Site Address: 32 CACHE RIVER CR SAC
Parcel No: 031-0640-009

Nature of Work: 29 SQ TO REROOF W PIONEER TILE

re: Job 2000_179: LAM

Subject: Structural Investigation Report of the Roof for the Residence located at 32 Cache River Circle, Sacramento, CA 95831.

1 ROOF PLAN - LAM
 Not to Scale

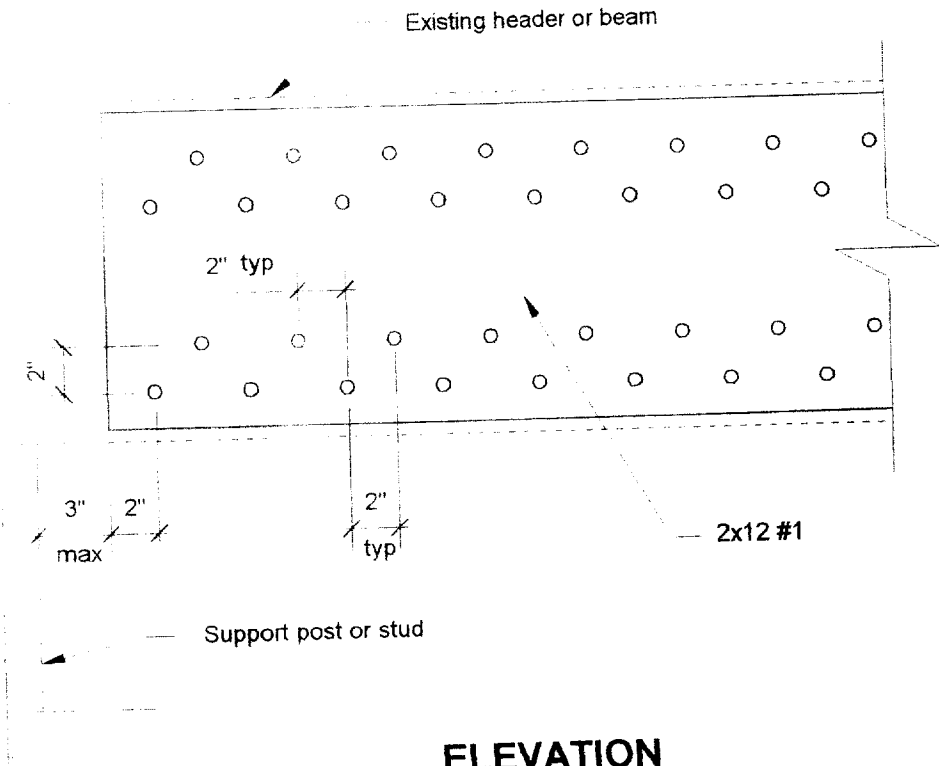
Max 2x4 span @ 24" o-c is 7'-9", per engineering
 verify adequate valley & ridge support in field
